Snow Vista Basin

Re: **Revised Grading and Drainage Plan for Sunrise Ranch Unit 2**
Engineer's stamp 11-7-00 (L9/D6)

Re: Amendment Report for A-H DMP for Sunrise Ranch Unit 2 dated 8-9-00
(L9/D6) Submitted to AMAFCA 10-9-00

SUNRISE RANCH UNIT 2
SUPPLEMENTAL INFORMATION

***SUNRISE RANCH UNIT 2
STORM DRAIN TO SNOW VISTA SEDIMENTATION POND***

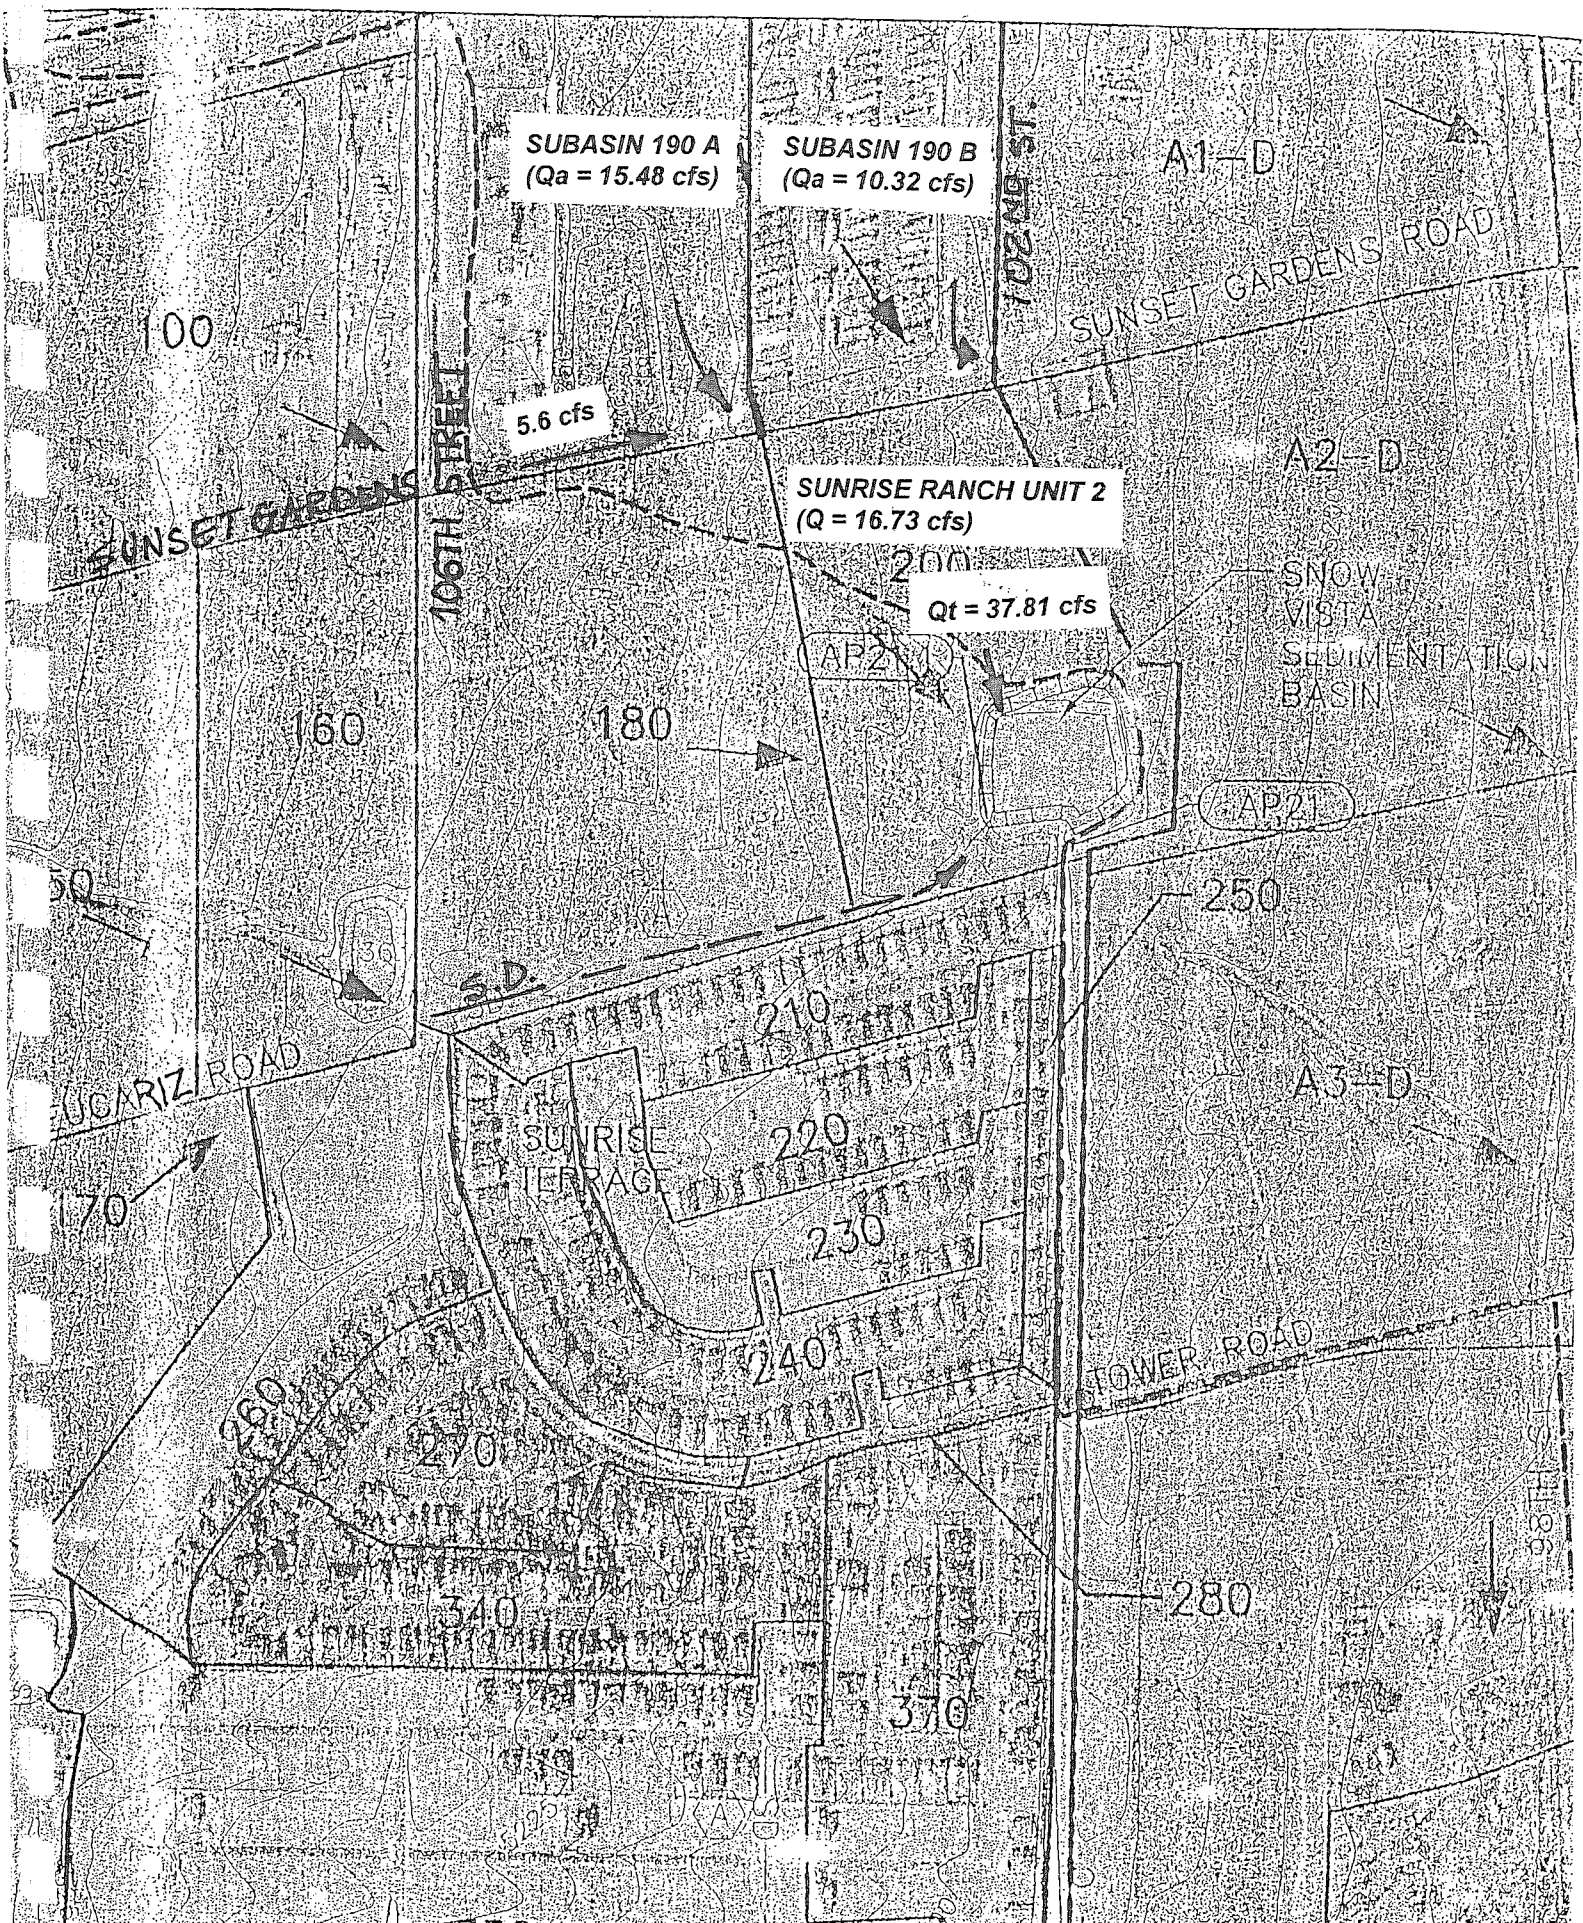
3. Please provide an Exhibit suitable for reproduction showing the revised drainage basins, facilities, etc. for the changes you are proposing to the A-H DMP. Also, provide table showing the revised flow rates at critical points for the above changes. AMAFCA can supply a copy of the DMP hydrology in digital format to assist you.

3. A reproducible mylar of Figure N-4 with revised subasin boundaries for subasin 190A and 190 B is being provided. The flows into the Snow Vista Sedimentation pond have been reduced and a table showing these changes at critical points has been prepared. (Refer to Appendix A)

SUBBASIN 190 A
($Q_a = 15.48$ cfs)

SUBBASIN 190 B
($Q_a = 10.32$ cfs)

SUNRISE RANCH UNIT 2
($Q = 16.73$ cfs)

$Q_t = 37.81$ cfs

TEMPORARY 98TH STREET SWALE

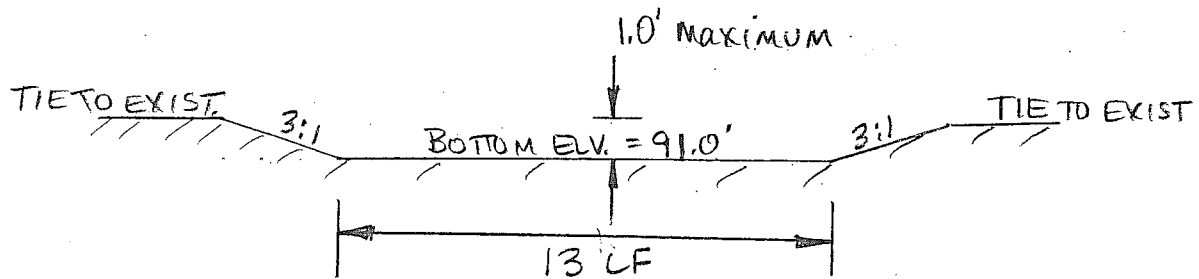
4. I repeat my comment from 7-5-00, what is the interim plan for picking up drainage on Sunset Gardens? Off-site flows are currently entering Unit 2 just south of Sunset Gardens (at lot 5, Block 7). If you plan to divert these flow to Sunset Gardens, does it have the capacity? What is the flow rate? If you plan to divert to the arroyo to the south you will need to build the facility you propose in 2 above.

4. A temporary swale within the 98th street right-of-way will pick up 'developed' flows from Sunset Gardens and temporarily retain them within the 98th street right of way until the SAD 222 storm sewer is constructed to intercept these flows early next year. A concurrence letter from City Hydrology will be provided. (Refer to Appendix B)

Sunset Gardens 36' (1420 CF) = 51,120 SF = .00183 sq.mi

AHYMO @ (100) = 4.15 cfs

Volume = .180 Ac Ft (43560) = 7840 CF

Scour Wall Calculations (Q100) (Eqn 3.88 SEDIMENT & EROSION DESIGN GUIDE)

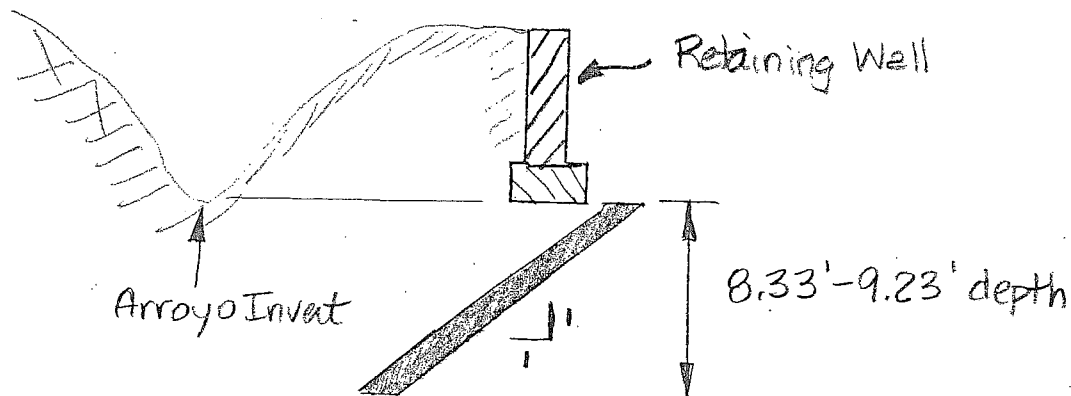
5. Show FEMA floodplain on plat as well as G & D Plan.
6. Are fences proposed at the property line for lots 17 and 18, Block 7? If the fence is within the erosion setback it will have to be extended down past scour depth.

5. The FEMA floodplain was shown on the grading and drainage plan dated 8-8-00 revised 10-6-00. The FEMA floodplain is not part of the Sunrise Ranch Unit 2 plat or any of the remaining Tracts currently shown on the Unit 2 plat.
6. Scour depth calculations have been submitted with this letter. A detail of the proposed scour wall is shown on the revised G&D plan. Scour calculations can be found in Appendix C).

INVERT - Y_s	Scour Wall Inv.
CS 1030	121.03 - 7.13'	113.90
CS 1046	121.40 - 7.13' =	114.27
CS 1076	121.80 - 7.13' =	114.67
CS 1102	122.30 - 7.13' =	115.17
CS 1130	122.65 - 7.13' =	115.52

CS 1046	123.5 - 114.27 =	9.23'
CS 1076	123.6 - 114.67 =	8.93'
CS 1102	123.5 - 115.17 =	8.33'
CS 1130	123.5 - 115.52 =	7.98'
CS 1030	123.5 - 113.90 =	9.60

Location	Scour Wall Elev.
	TOP BOTTOM
XS 1030	123.5 113.9
XS 1046	123.5 114.27
XS 1076	123.5 114.67
XS 1102	123.5 115.17
XS 1130	123.5 115.52
